ISSUE DATE: 5/8/07
 APPROVAL DATE: 5/23/07 (KW)
 P 526690
 A REPAIR

**ON-SITE SEWAGE DISPOSAL SYSTEM
 HOWARD COUNTY HEALTH DEPARTMENT
 BUREAU OF ENVIRONMENTAL HEALTH**

RE: **Variance Approval**
3105 Argent Path
Ellicott City, MD 21042

**RE: Pavilion Building Permit Proposal
Brantwood Subdivision, Section 1, Lot 23**

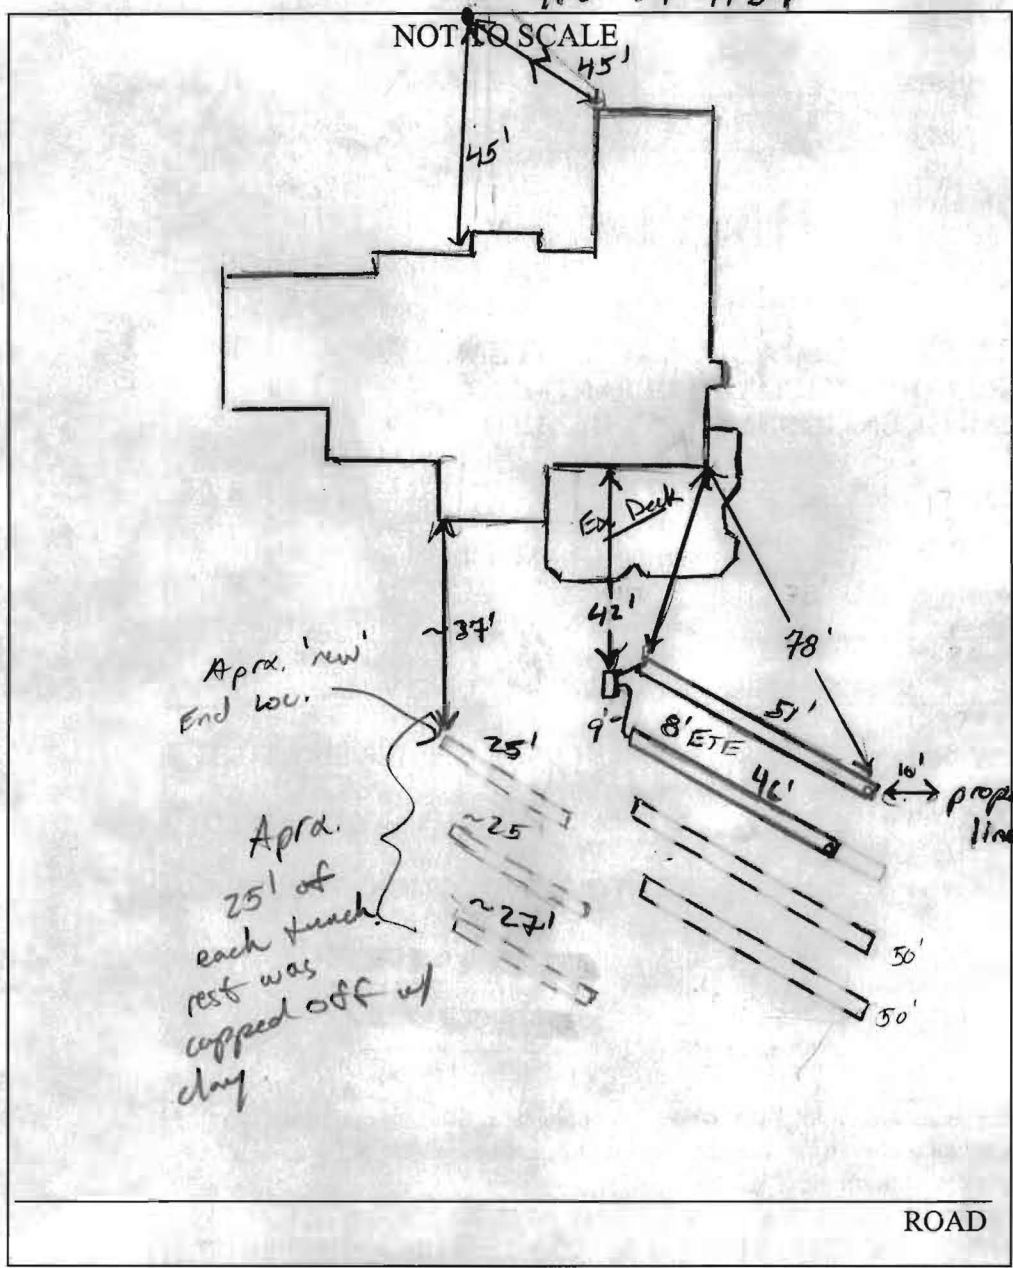
LINEAR FEET OF TRENCH REQUIRED: 186 50' Minimum
Need to Add 50' Trench. (KW)

PRE-CONSTRUCTION 5/8/07 At time of site insp., top 2 trenches are to be abandoned. One below those two

INSTALLATION to be abandoned roughly 35'. Aprx. 38' of bottom 75' trench to remain. Layout of new ~50' trench addition to be given @ time of layout insp. (KW)

5/21/07 Contractor to abandon 20' back of trench from prop pool and fill w/ clay material. 2 x 50' trenches to be installed above 2 ex 50' trenches. (KW)

5/23/07 2 trenches installed per layout installation. 2 trenches placed in Area 'A' according to previous system 'as-built' OK to backfill trenches. Digging up old trench capping off ~10' back from 20' setback to pool. (KW)

5/23/07 Top trench resin pipe was used. Fabric used on 2nd trench. Sys. complete. *Lowes adj. for 3x25' trenches for 80% flow. Sys. complete

Pool Context Plan

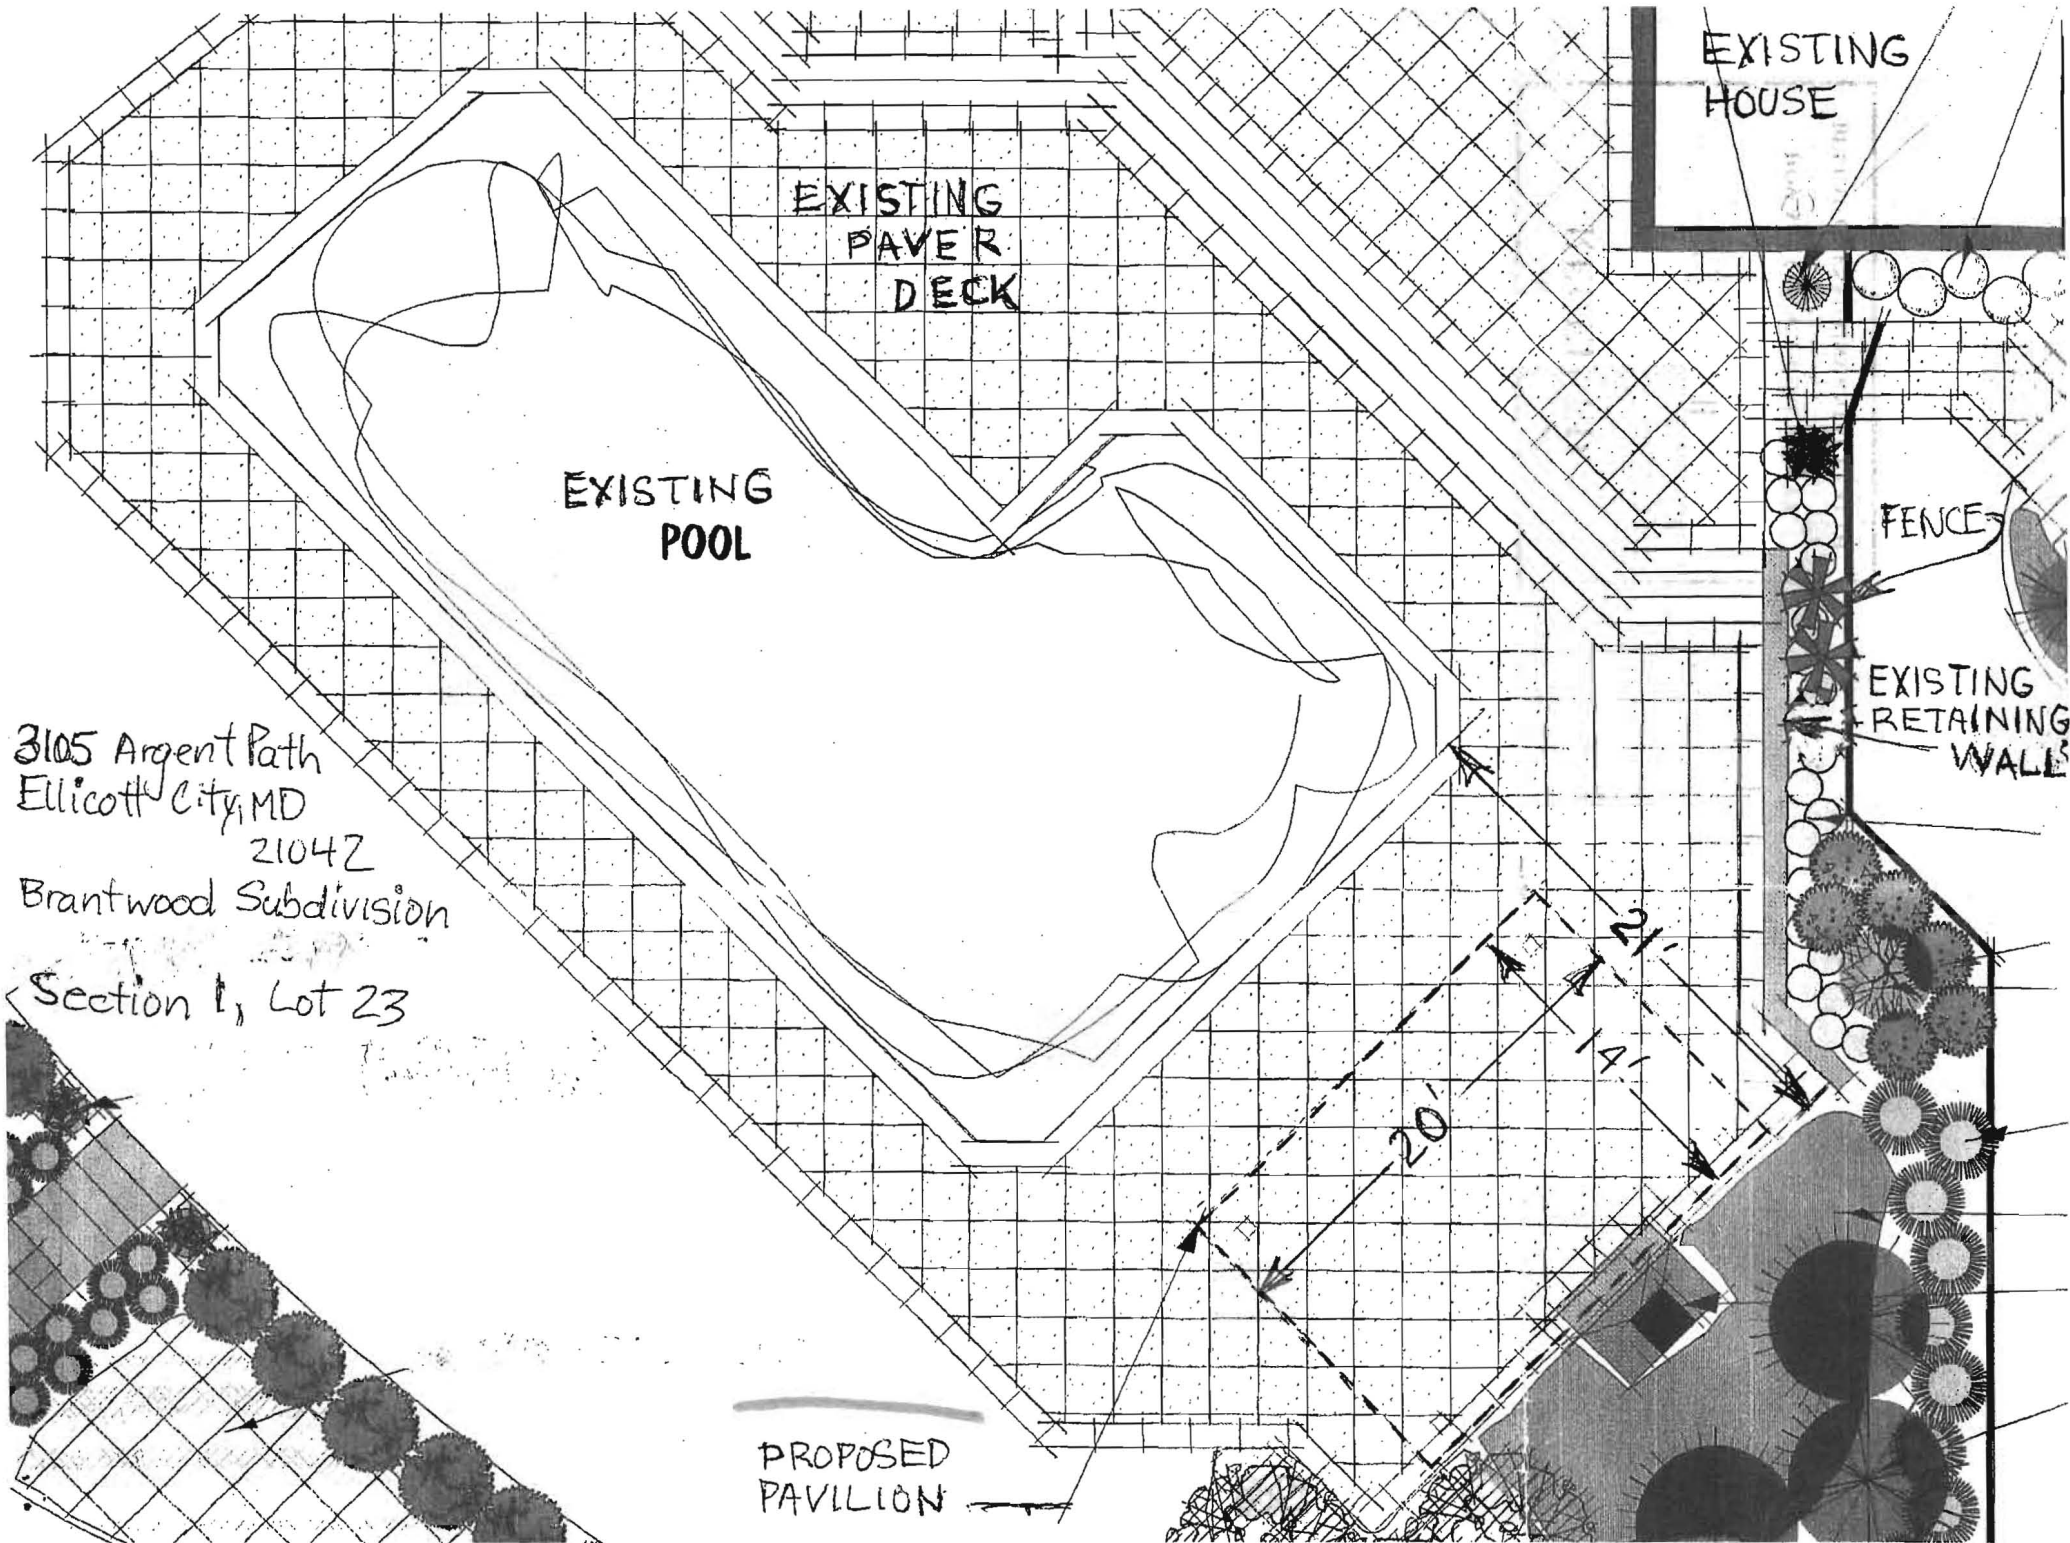
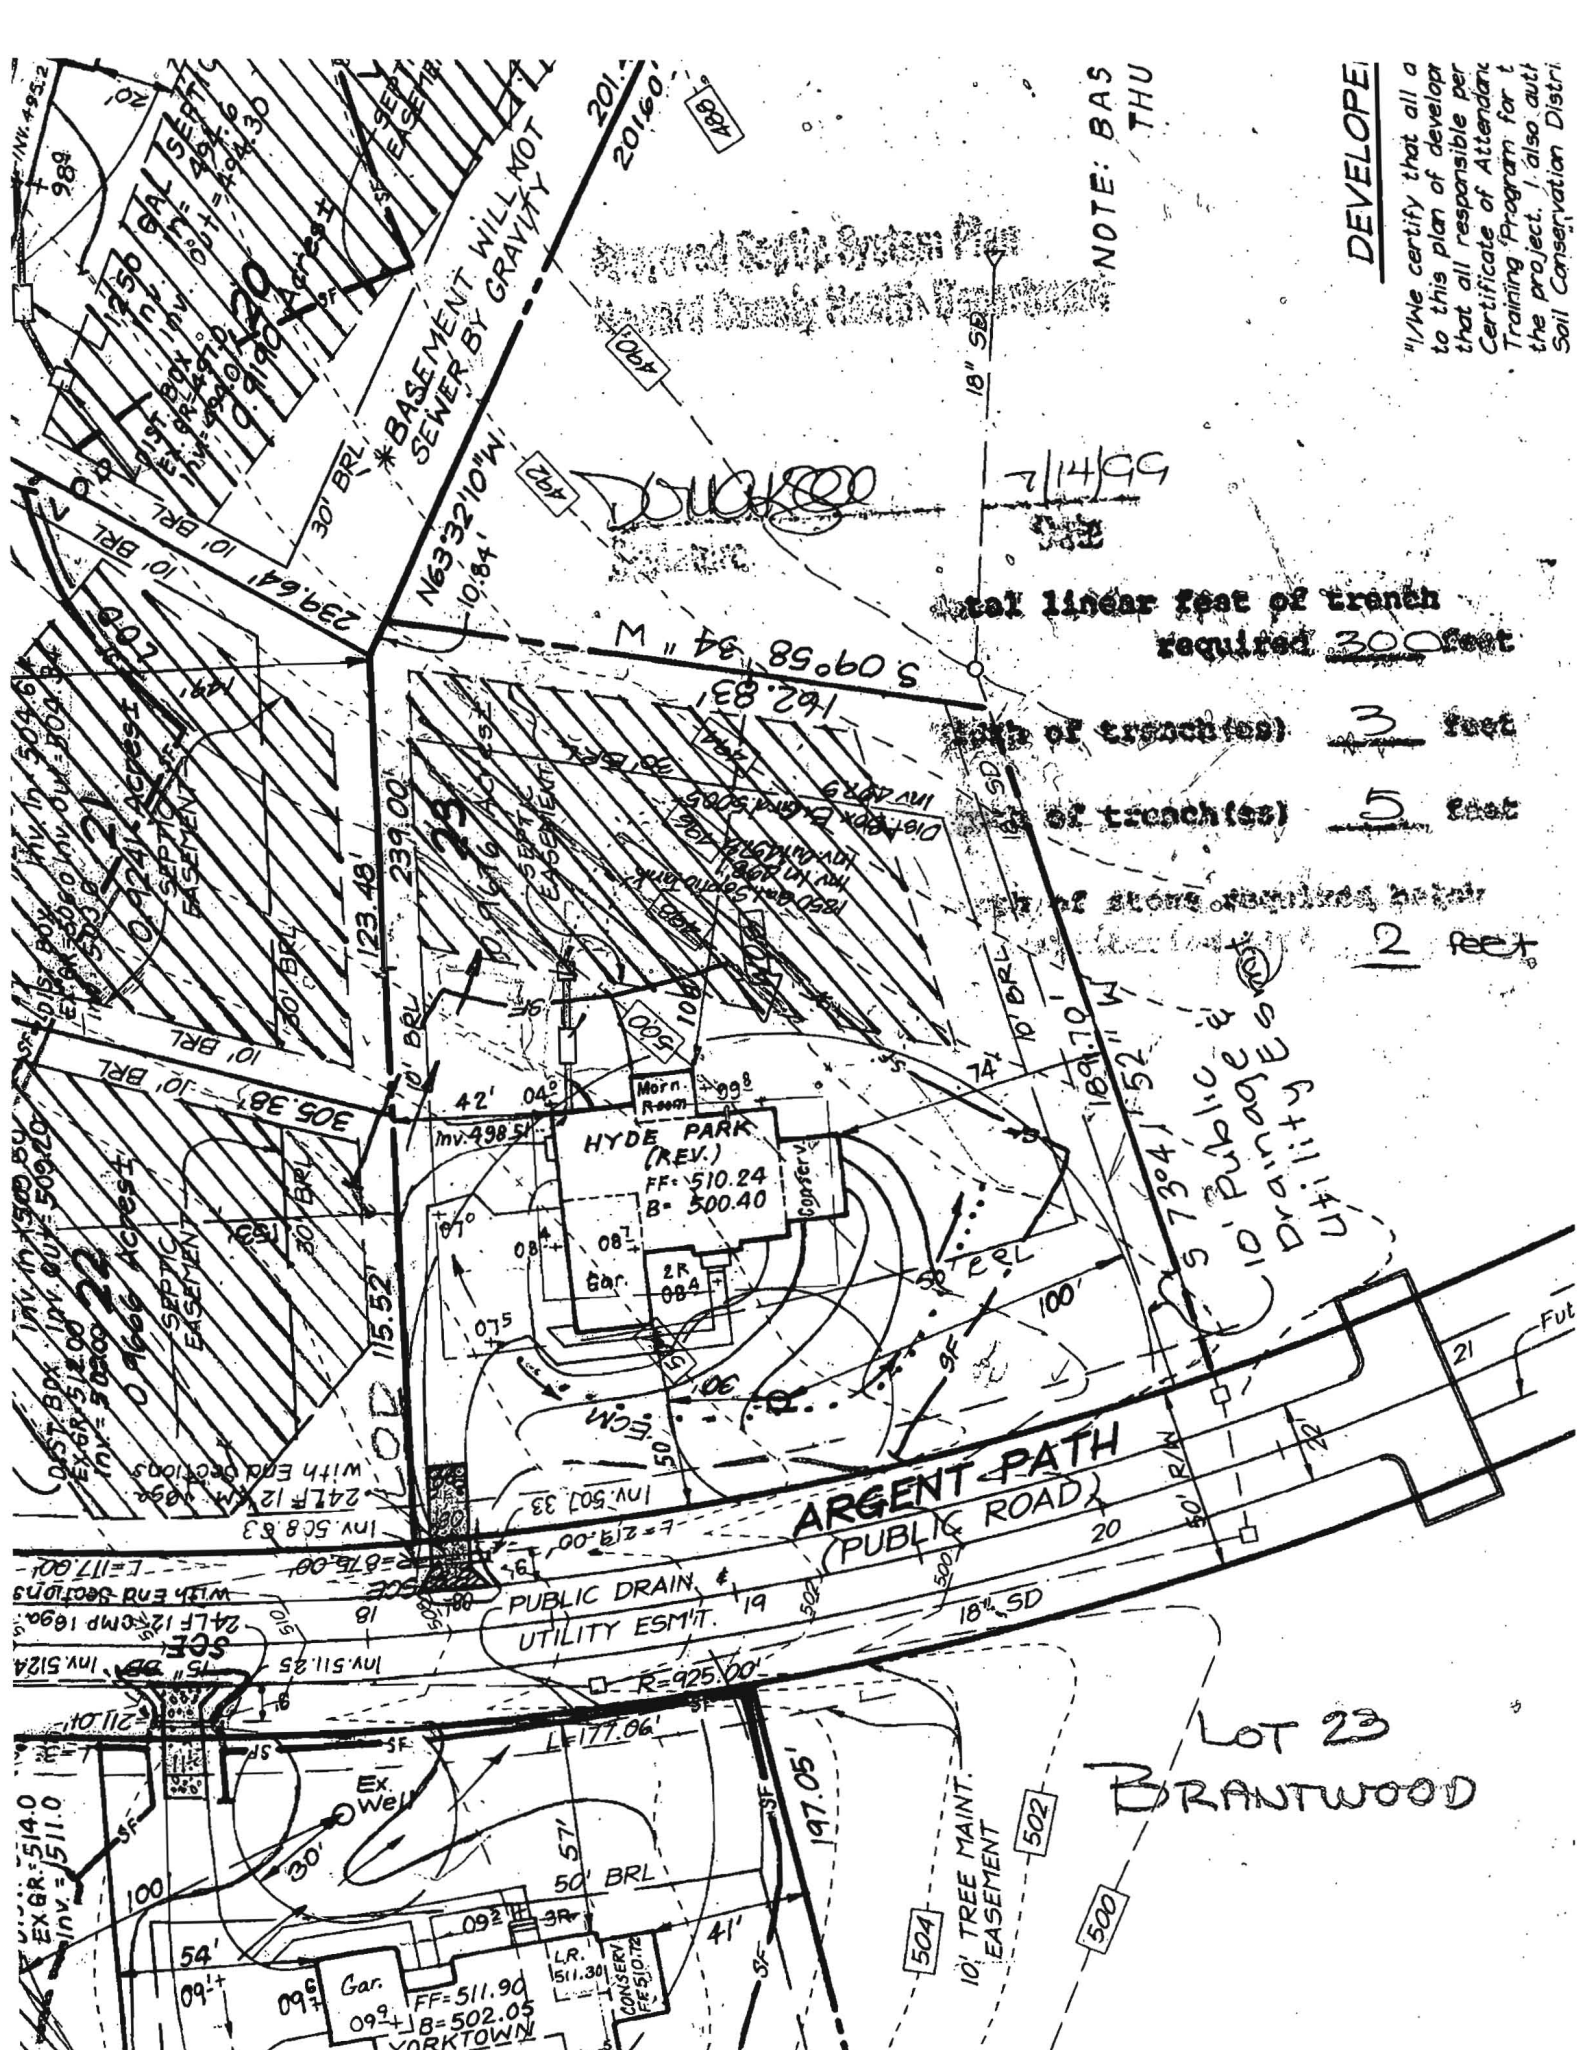
The concern at issue is that the northeast perimeter of the proposed structure would be within 1' of the currently documented septic reserve area. With reference to discussion with Mr. Robert Bricker from your office on August 12, I understand that the proposed pavilion would not be in compliance with the required 5' septic easement according to code.

Therefore, I respectfully request variance approval for the 5' septic easement to deck/patio easement requirement. Specifically, I request that the easement requirement

from the 20' long northeast face of the proposed structure to the adjacent septic area be waived.

If the request to waive the requirement is not acceptable, an alternative approach might be to reallocate septic reserve area to maintain an area exceeding 10,000 square feet as follows: Remove approximately 100 square feet of septic reserve in the area in question adjacent to the proposed structure to maintain the required 5' easement. Add an offsetting amount of reserve from the area between the existing wood deck at northeast side of the house and the currently approved septic area. Note that the currently configured septic area was calculated with an incorrectly assumed easement requirement of 10' to the deck, and the actual distance required is only 5'. Reallocation from that area could exceed the potential removed area, thus maintaining the calculated reserve area in excess of 10,000 square feet without requiring an additional variance.

The Health Department received your waiver request dated August 16, 2011 to allow a proposed pavilion to encroach within one (1) foot of the existing sewage disposal area. The encroachment is in the area of the existing system and it is unlikely that additional on-site sewage disposal trenches will be installed in this location. Therefore, your waiver has been approved. Please be advised that the four corner posts should not be located over any of the existing trenching. Any deviation from the plan submitted with your waiver request requires review by this Department.
